From: Andrew Leon <andrew.leon@mercerisland.gov>
Sent time: 2022/08/29 02:00:14 PM
To: Clayton Herbst <clayton@shedbuilt.com>; Prentis Hale <prentis@shedbuilt.com>; Greg Shiffler <greg@shedbuilt.com>
Cc: Ryan Harriman
Subject: RE: PRE22-043 Notes
Attachments: image001.png image002.png image003.png image004.png image005.png

Thank you for attending the virtual Pre-Application Meeting earlier this week to discuss a proposal to construct a new single-family residence at 3024 69th Ave SE. I have attached the staff notes for the meeting to this email. If you have any questions, please reach out to the respective staff contact listed in the notes.

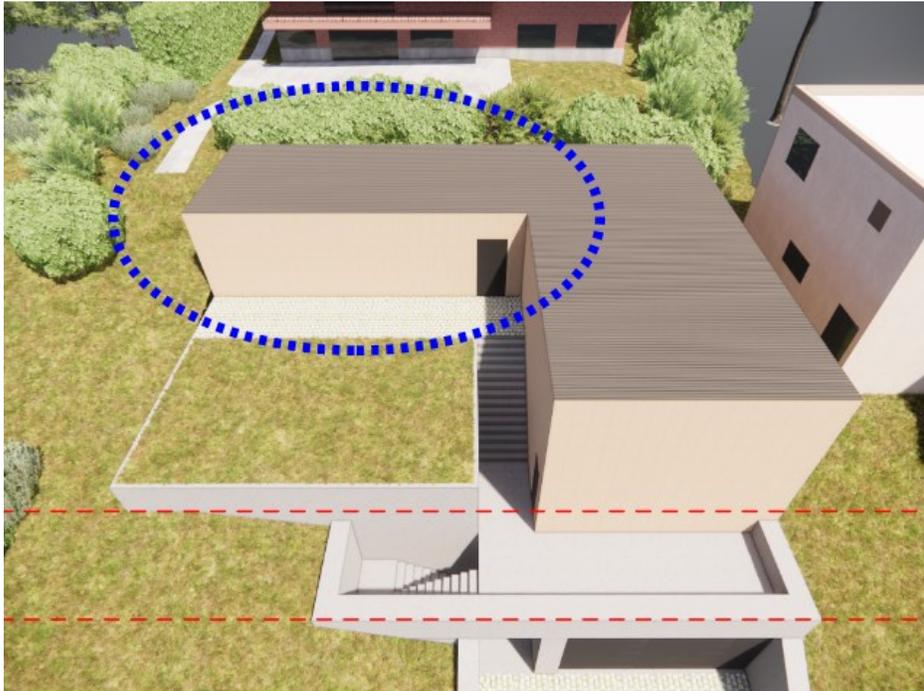
>**question 4:** were we able to get confirmation that the 30' height limit is only applicable to the westernmost/downhill facade and not the back portion of the house circled in blue below?

The portion of the house circled in blue above would need to meet the 30-foot height limit above the average building elevation. The circled portion would not need to be subject to the 30-foot façade height limit from the furthest downhill extent, which would apply to the portion of the house which is closest to the street.

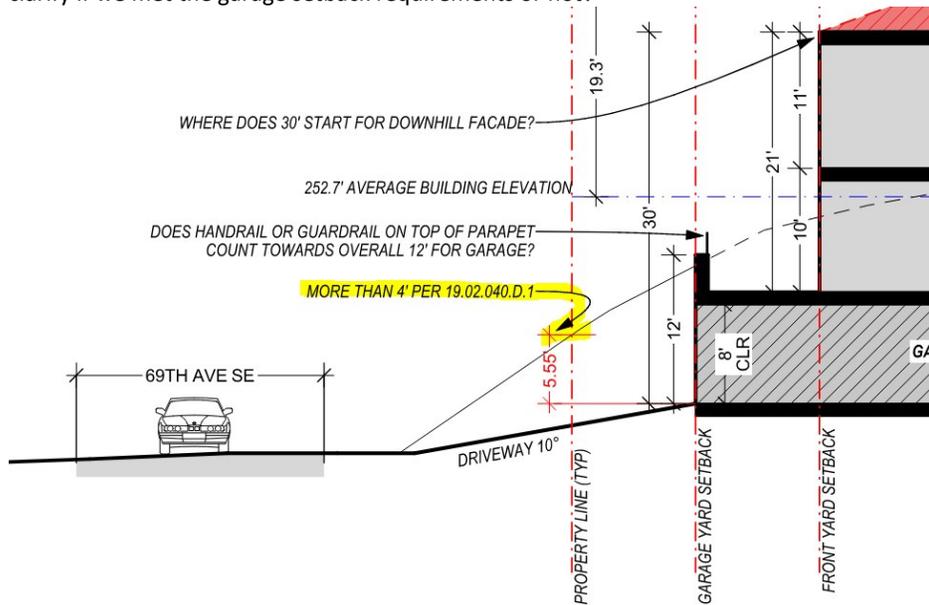
>question 15: we had gotten verbal approval from you that our measurement below for the garage was correct, this is contradicted by your response in the notes that say it appears TO NOT meet the 4' requirement. can you please clarify if we met the garage setback requirements or not?

After the meeting on Tuesday, I revisited the code section regarding when a garage can be located within the front yard setback. MICC 19.02.040(D)(1) states that a garage may be located 10 feet from the front property line when there is greater than 4 vertical feet measured between the elevation at the bottom of the wall of the building and the ground elevation at the front yard property line where such property line is closest to the building. The elevations of both the intersection of the building and the ground, and the point of the property line closest to the wall of the building, shall be measured using the lower of the existing and finished grade.

The diagram above shows the elevation difference being measured from the vertical midpoint of the exterior wall of the garage. When I measured the difference of the elevation of the bottom of the exterior wall of the garage and the elevation of the front property at the driveway, the difference was about 2 feet. As proposed, the location of the garage would not meet the standards of MICC 19.02.040(D).

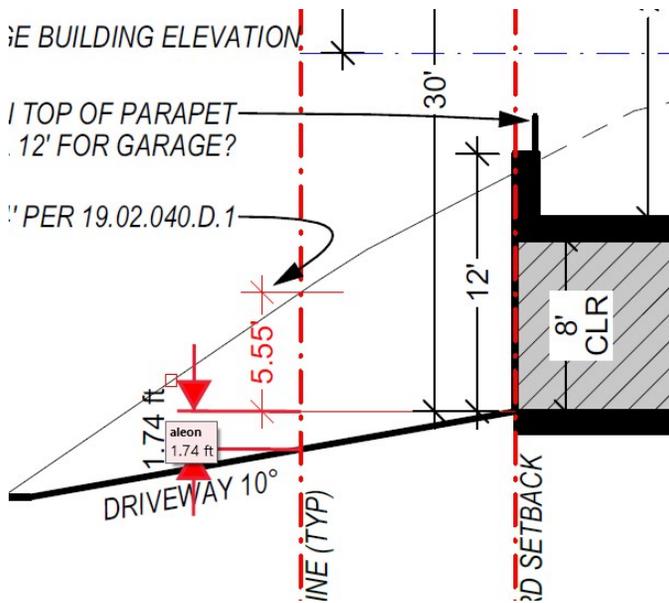
>question 16: we were told that guardrail would not count towards the 12' max which the note in this doc says otherwise. please clarify.

I discussed this issue with my manager. We determined that the exclusion of appurtenances from the building height allowed under MICC 19.02.020(E)(3) only applies to the main structure and would not apply to accessory structures, including the portion of the garage within the setback. The maximum allowed height for the portion of the garage, including parapet and railings, would be 12 feet above the lower of existing or finished grade.

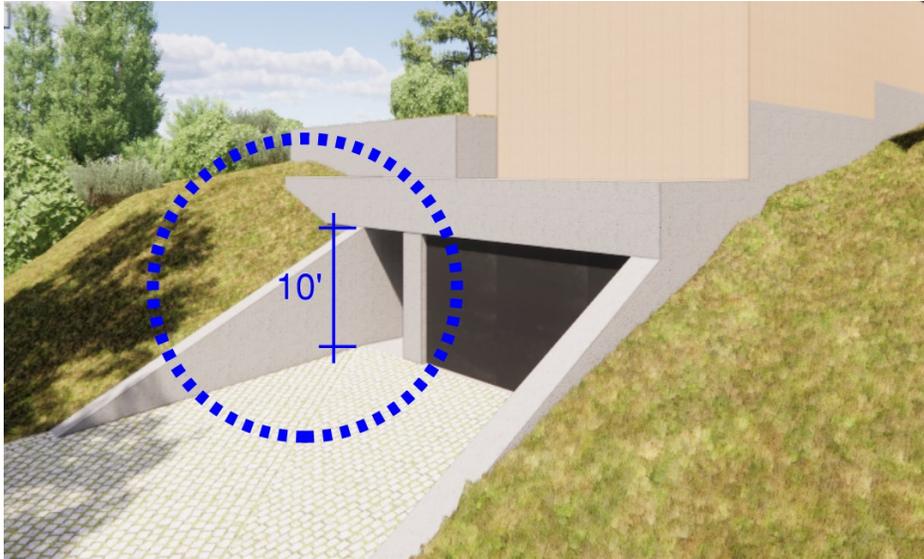
>retaining wall in yard: had a question about the allowable retaining wall heights in yards. we had discussed that they were only allowed to be 48" tall, however the notes in this doc it says that they are allowed to be up to 144" in height.

though maybe not applicable for the stairs i wanted to confirm that our proposed retaining walls for the driveway were still allowable per this section (circled in blue in the screenshot below)

MICC 19.02.050(E)(1)(a)(ii) states that fences, gates, or any combination of retaining walls, rockeries, and fences are allowed to a maximum height of 42 inches within the front yard setback. This means that all retaining walls within the front yard setback are limited in height to 42 inches. Since this section is more restrictive, it overrides the section you copied above.
